Technical Service Information

REVERSE SHUDDER 1984 300ZX TURBO

APPLIED MODEL: 3584 300ZX turbo with automatic transmission. APPLIED VIN:

Figure 1

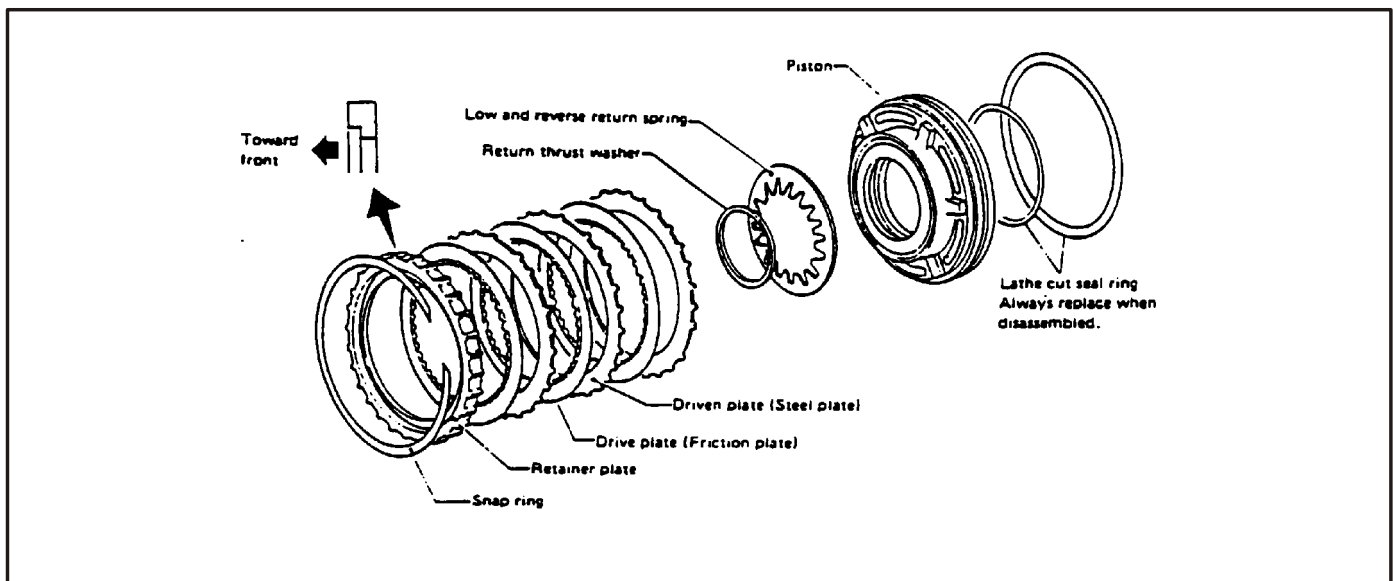
Some 1984 300ZX Turbo models with automatic transmissions may exhibit a shudder while backing up in reverse gear. To eliminate this condition, the number of drive and driven plates in the low and reverse brake of 4N71B turbo automatic transmissions have been increased from 7 to 8 beginning with the Applied VIN below. Because of the additional plates, the transmission case has also been modified.
